INDIAN POINT NUCLEAR GENERATING UNIT NO. 2

Amendment No. 26
License No. DPR-26

INDIAN POINT NUCLEAR GENERATING UNIT NO. 3

Amendment No. 5
License No. DPR-64

Figure 6.2-1 Facility Management and Technical Support Organization

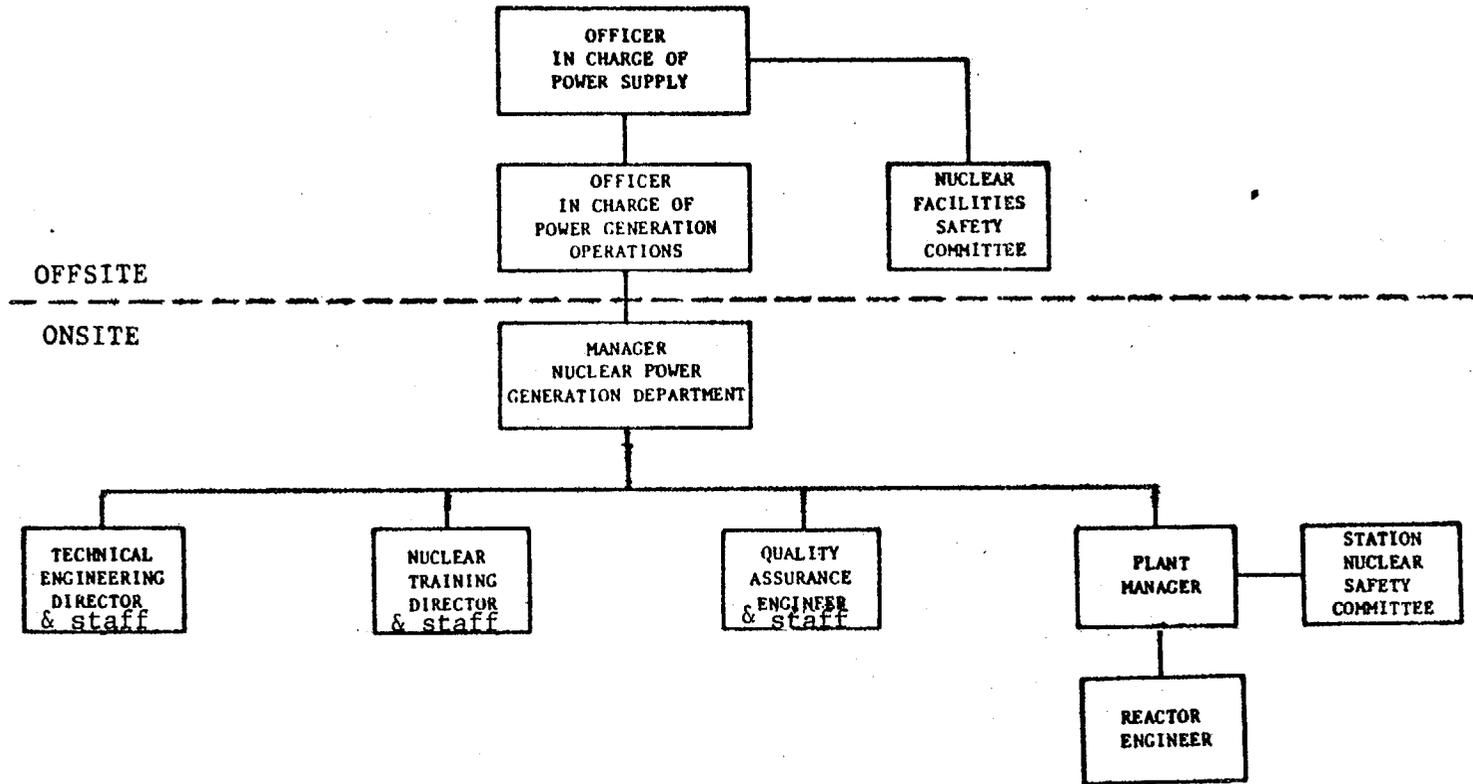
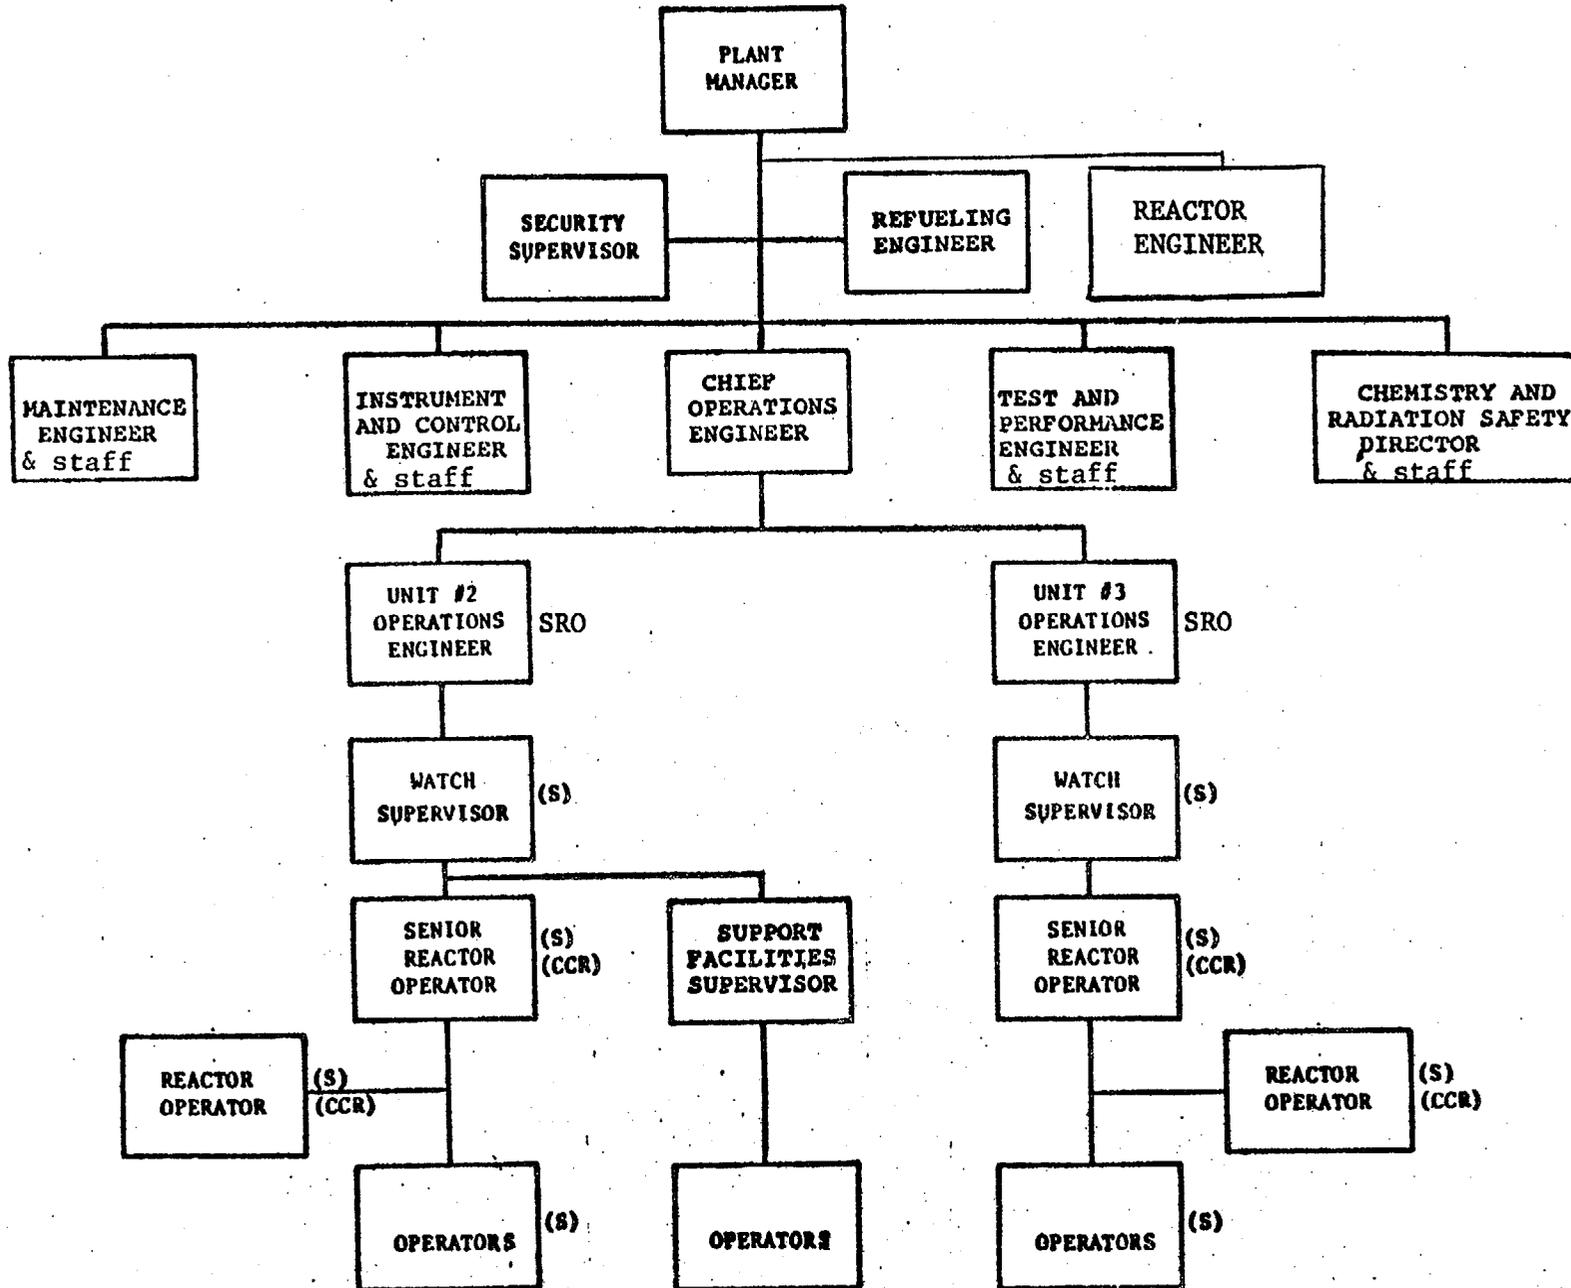
Changes were made in the organizational charts (figures 6.2.1 and 6.2.2) to more clearly reflect the fact that certain engineers and directors had staffs reporting to them. The composition of the Station Nuclear Safety Committee was modified to include the Manager, Nuclear Power Generation as a member. The highest level on-site manager would therefore be more directly informed of safety considerations and would also participate in such considerations by the committee.

6.2.1 The organization for facility management and technical support shall be as shown on Figure 6.2-1.

6.2.2 The Facility organization shall be as shown on Figure 6.2-2 and:
